AMENDMENT OF SOLICITATION/MODIFICATION OF CONTRACT				1. CONTRACT ID CODE J		PAGE OF PAGES 1 13	
2. AMENDMENT/MODIFICATION NO. 0002		3. EFFECTIVE DATE 16-May-2002		4. REQUISITION/PURCHASE REQ. NO. W16ROE-2046-6819		5. PROJECT NO.(If applicable)

AMENDMENT NO. 2
AVIATION BRIGADE VEHICLE MAINTENANCE FACILITY
May 15, 2002
U. S. ARMY CORPS OF ENGINEERS
NEW YORK DISTRICT
DACA51-02-R-0008

EXHIBIT A-32A

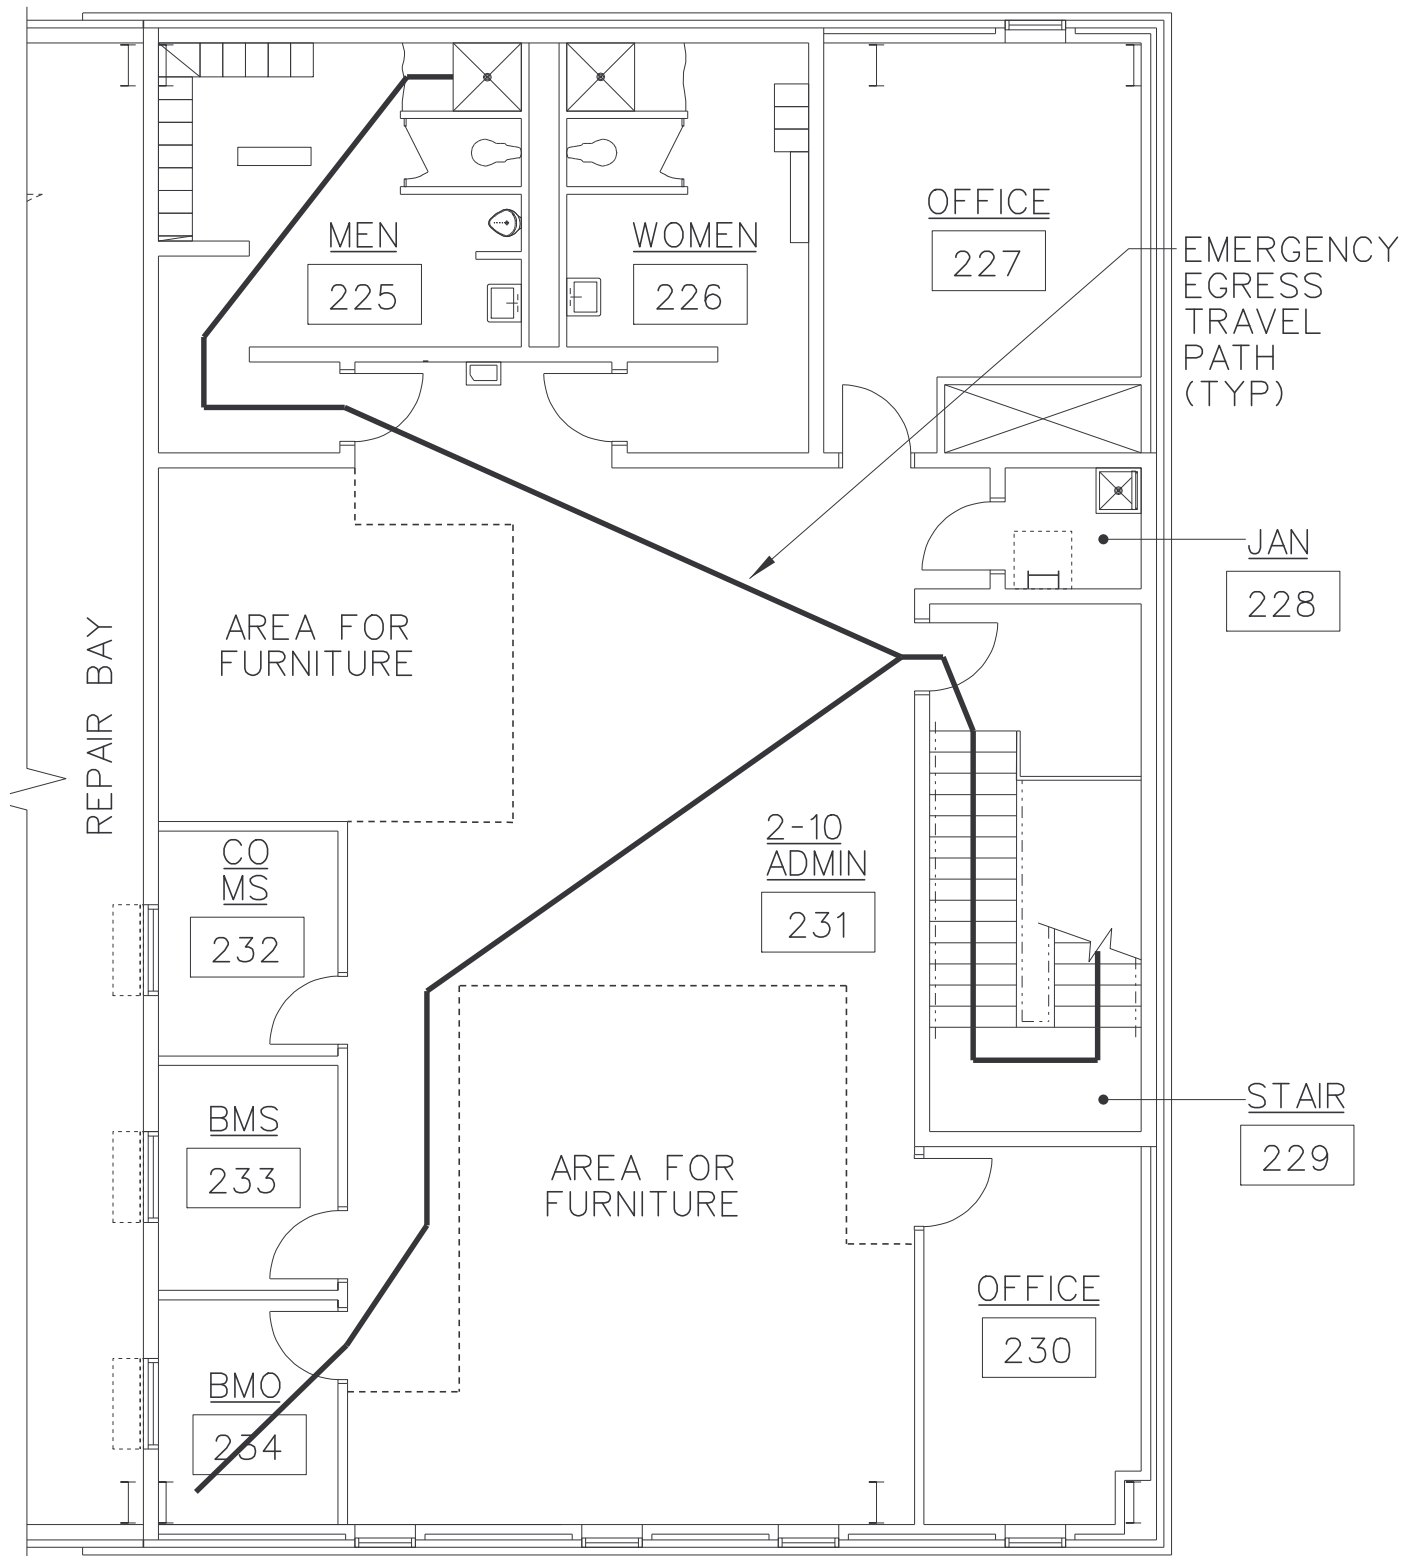
7. Drawing A-32

In drawing zone E2, change distance to exits from "26,213 mm" to read "28,300 mm".

Add attached Exhibit A-32A and Exhibit A-32B to Drawing.

EXHIBIT C-40A

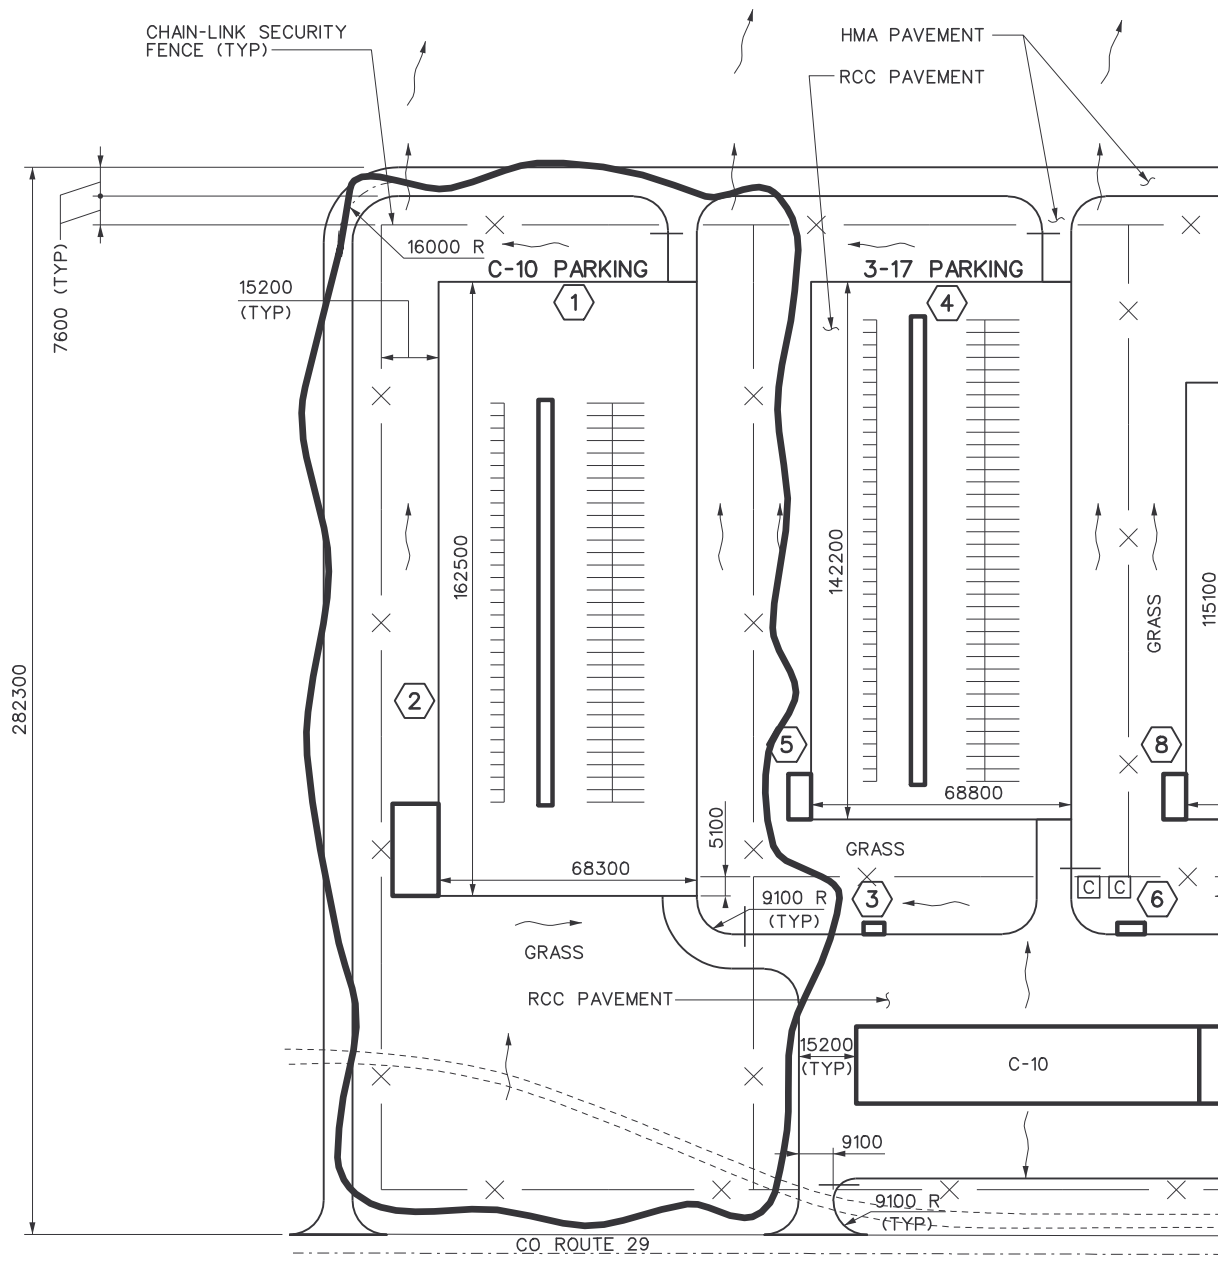
6. Drawing C-40

Revise C-10 parking lot dimensions, access drive, perimeter fence, and gate in accordance with attached Exhibit C-40A.

SITE LAYOUT PLAN
UNIT HHC-3/5 PARKING
 SCALE: 1:2000

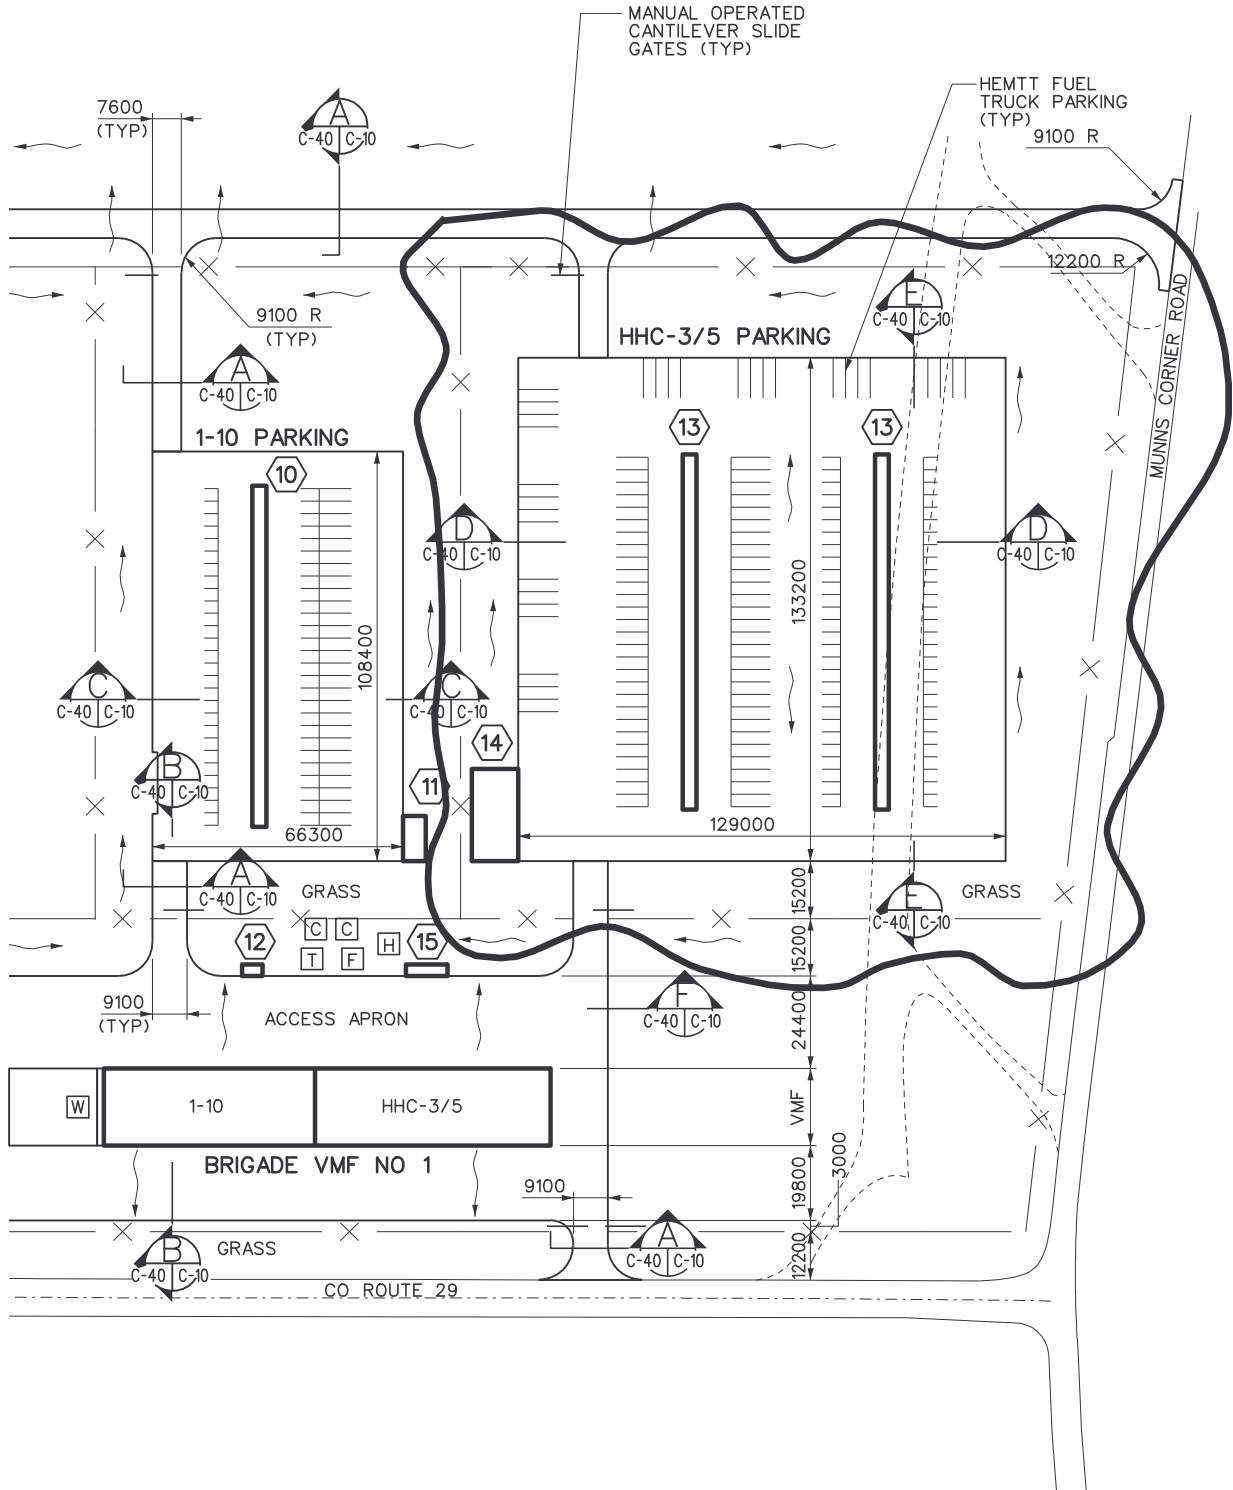
Revise HHC-3/5 parking lot dimensions, perimeter fence, and add six parking spaces for HEMTT fuel truck in accordance with attached Exhibit C-5B.

Revise HHC-3/5 parking lot dimensions, perimeter fence, and add six parking spaces for HEMTT fuel truck in accordance with attached Exhibit C-40B.

EXHIBIT C-5A

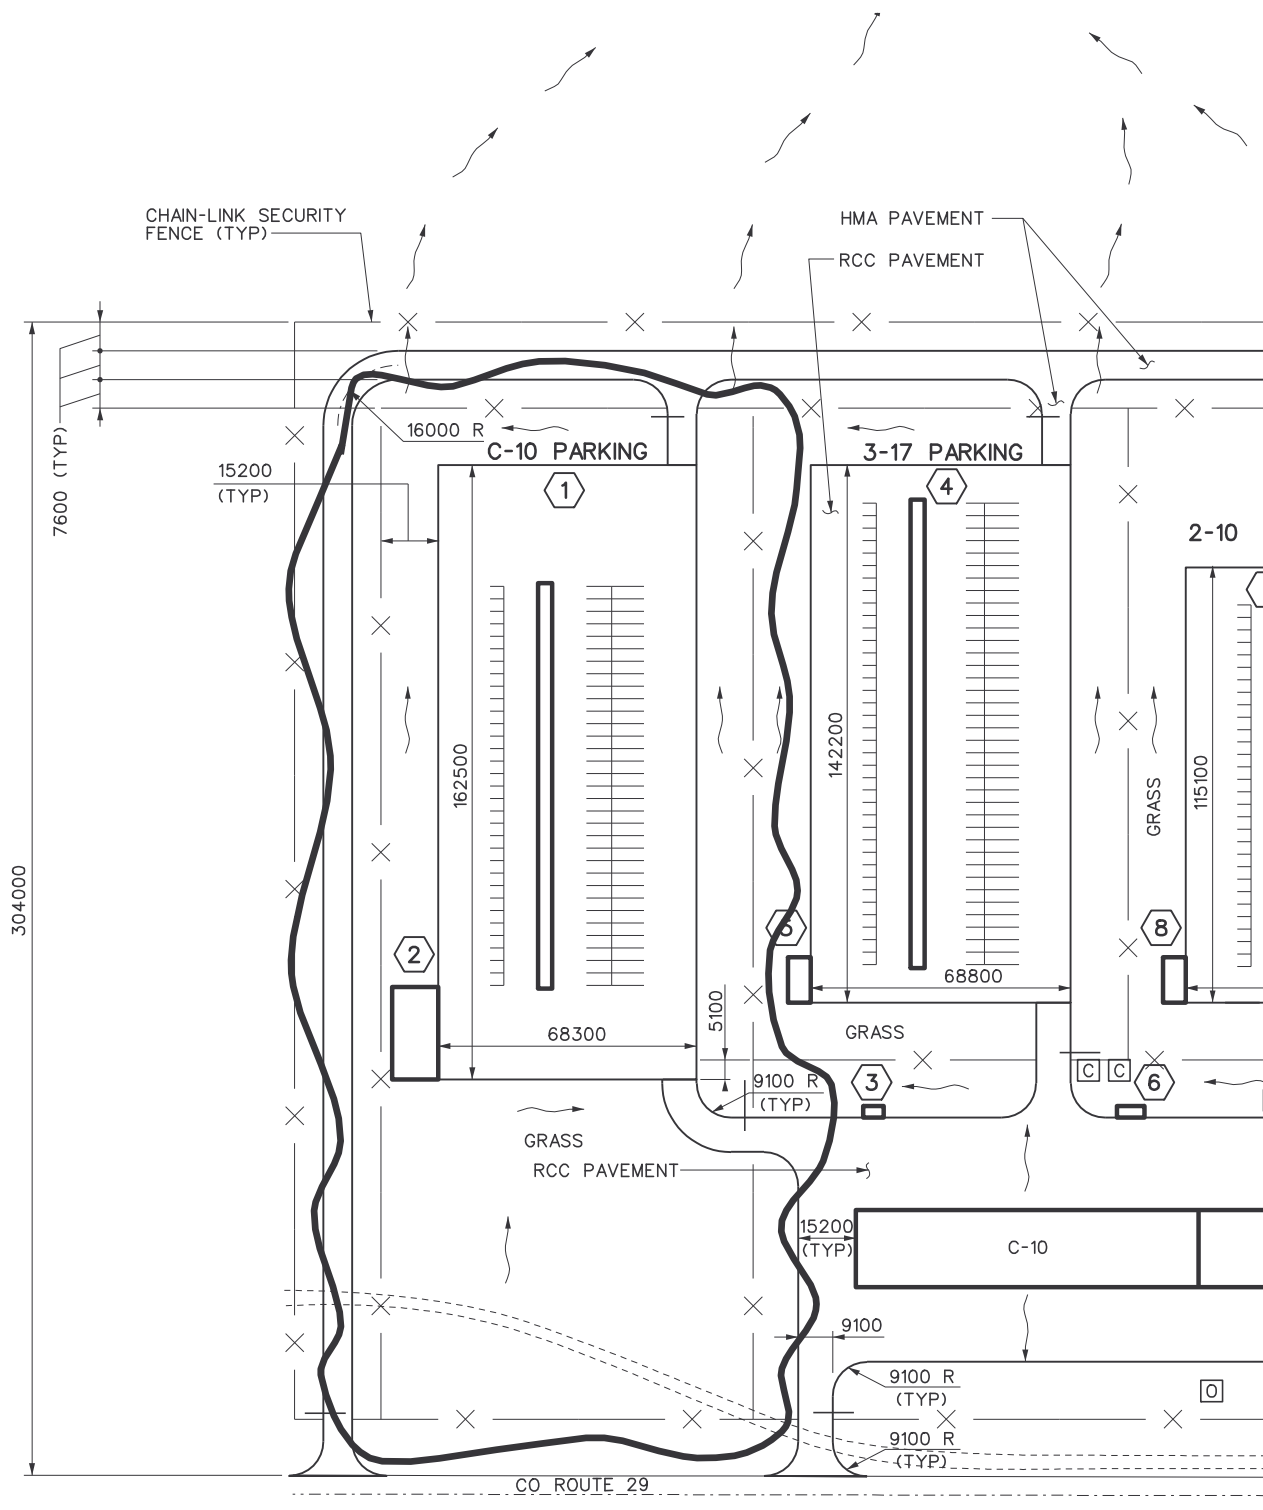
3. Drawing C-5

Revise C-10 parking lot dimensions, access drive, perimeter fence and gate in accordance with attached Exhibit C-5A.
